| CONTRACT NO. 66294  |             |                           |                 |              |

| SUMMARY OF QUANTITIES |                                                          |       |            | CONSTRUCTION TYPE CODE |                     |                      |                     |                      |                     |

REVISED  
4-11-2006  
PER ADDENDUM

ILLINOIS DEPARTMENT OF TRANSPORTATION  
FAI ROUTE 80 (I-80 AT MINOOKA INTERCHANGE)

ILLINOIS DEPARTMENT OF TRANSPORTATION  
 FAI ROUTE 80 (I-80 AT MINOOKA INTERCHANGE)  
 TEMPORARY LIGHTING  
 RAMP "B" AND RAMP "D"  
 SHEET 2 OF 2  
 STAGE 1

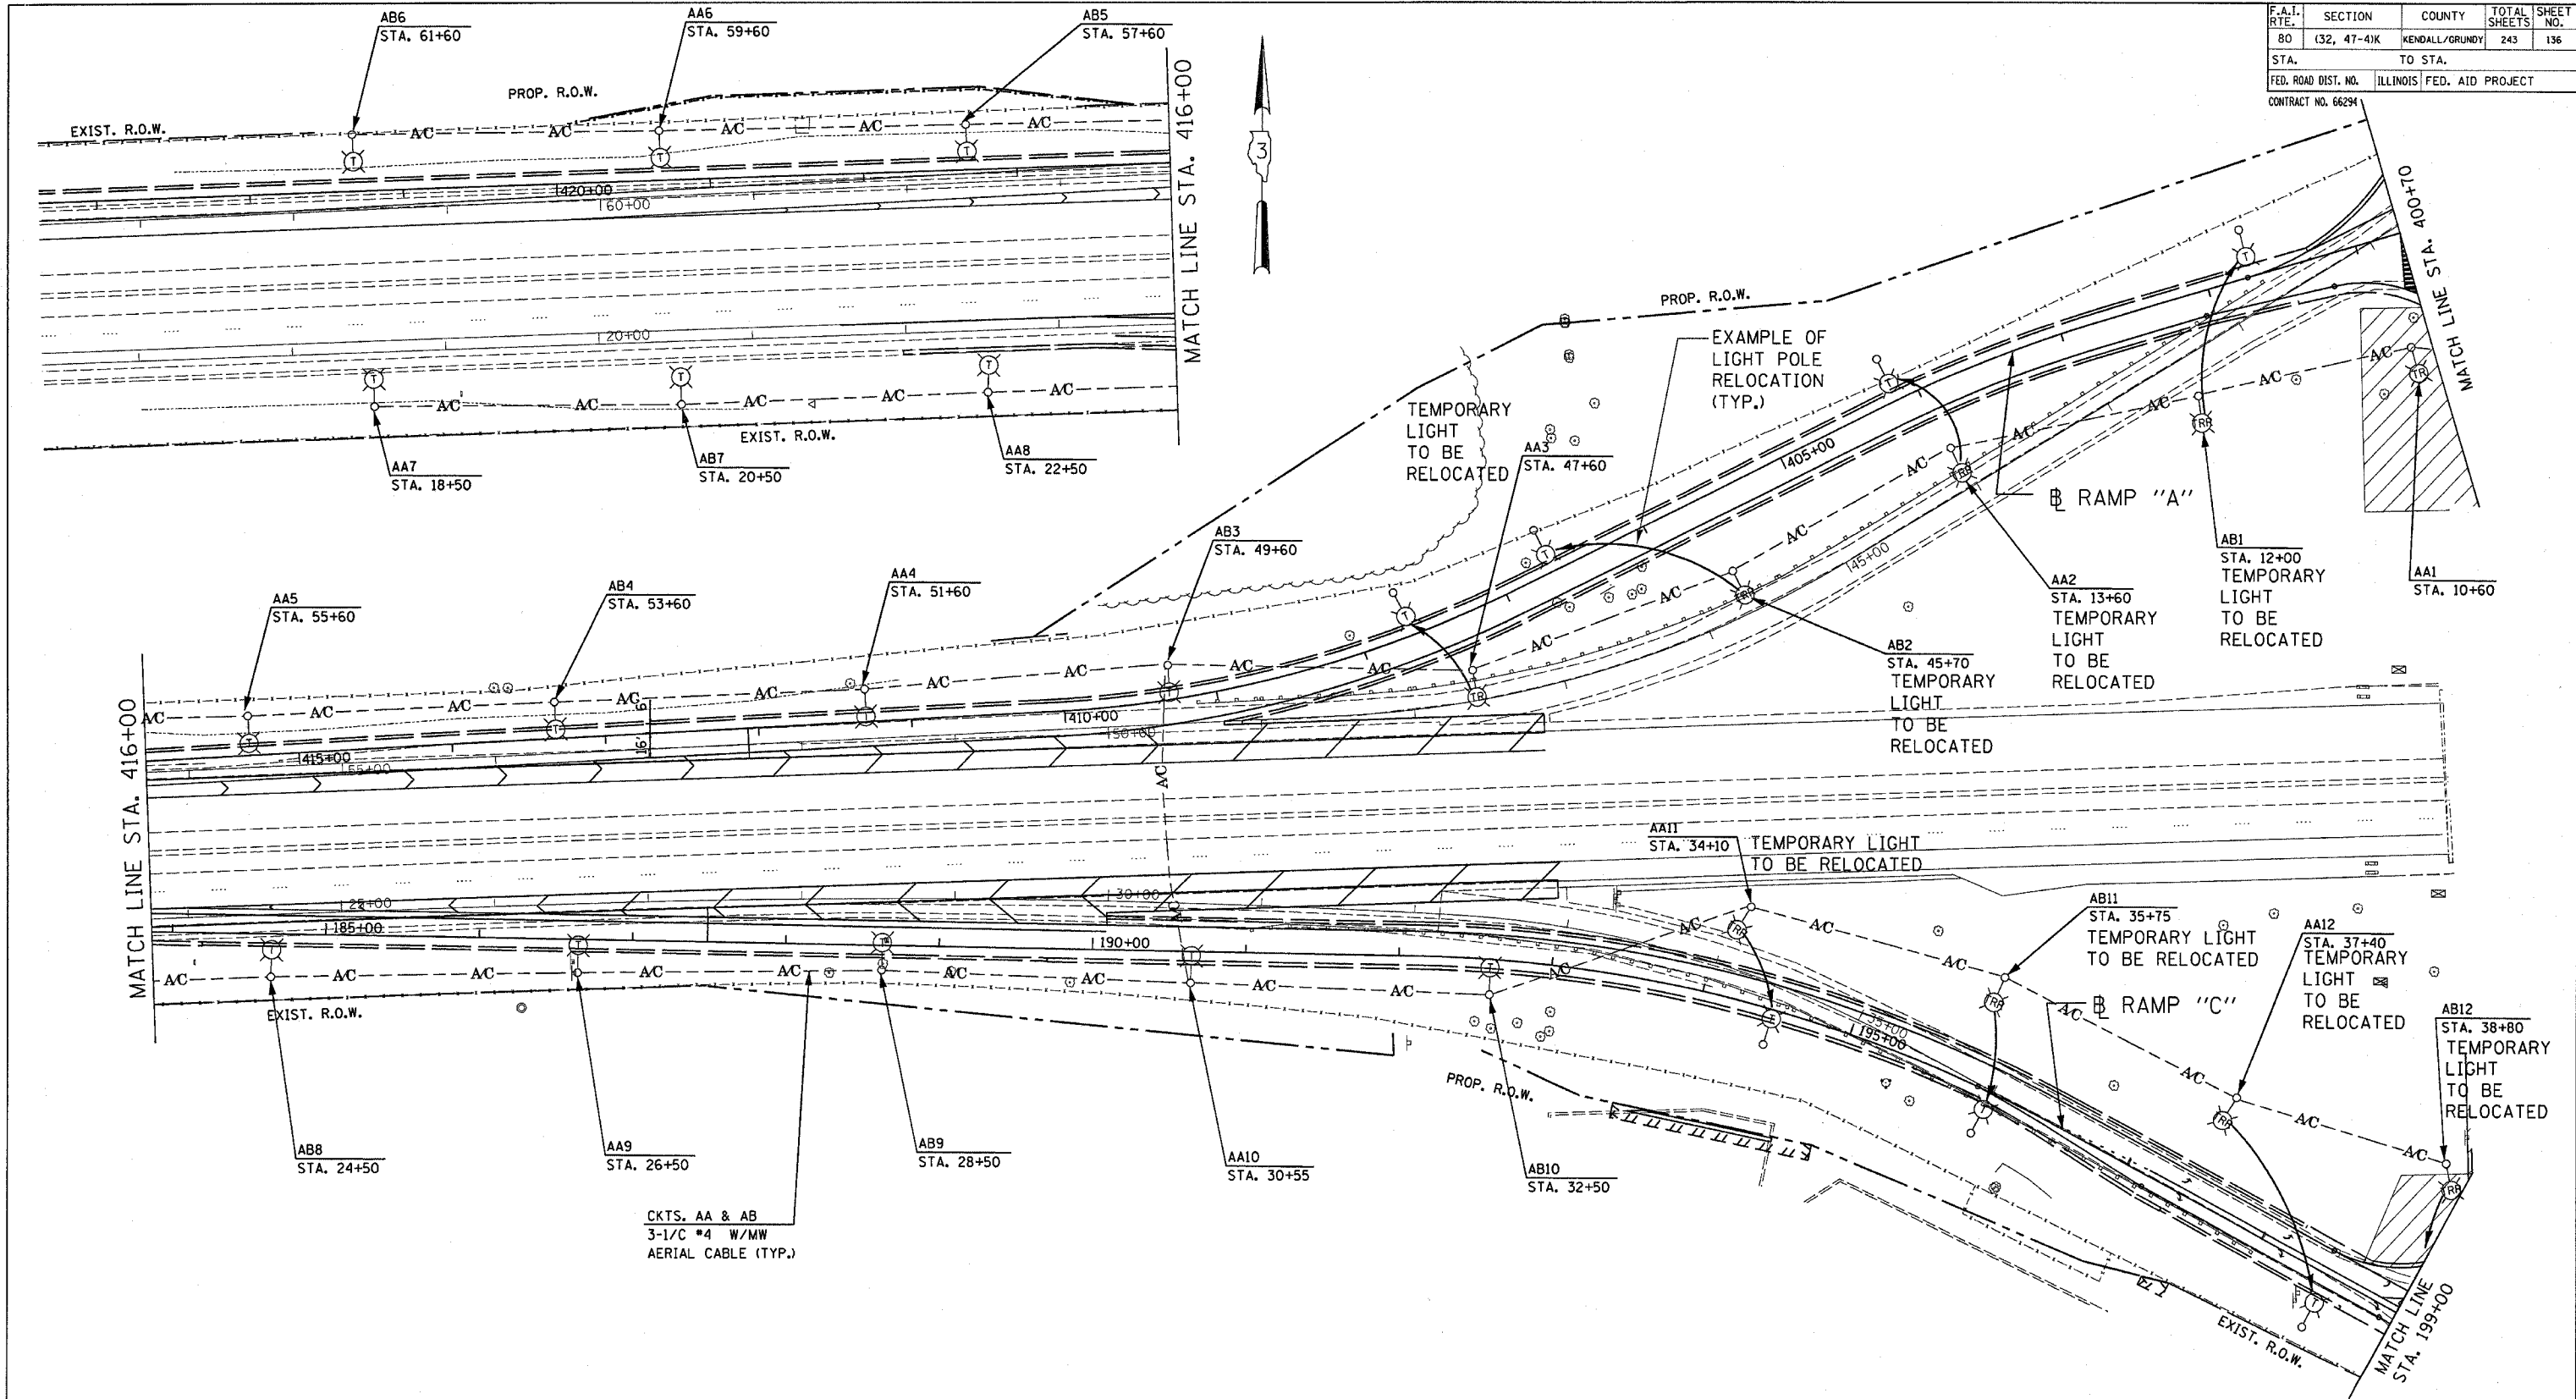
- NOTES:**
- ALL LIGHTING WORK SHOWN IN THIS PLAN SHALL BE INSTALLED, TESTED, AND MADE FULLY OPERATIONAL PRIOR TO COMMENCEMENT OF STAGE 1 CONSTRUCTION.
  - RELOCATE ALL EXISTING WOOD POLES
  - EXISTING METAL POLES OR LUMINAIRES MAY BE SALVAGED AND USED AT THE CONTRACTOR'S OPTION.

RELOCATE EXISTING TEMPORARY LIGHT POLES - 26 EACH TOTAL STAGE 1  
 TEMPORARY LIGHTING 20 EACH TOTAL STAGE 1 - (CAN BE SALVAGED FROM EXISTING METAL POLES)
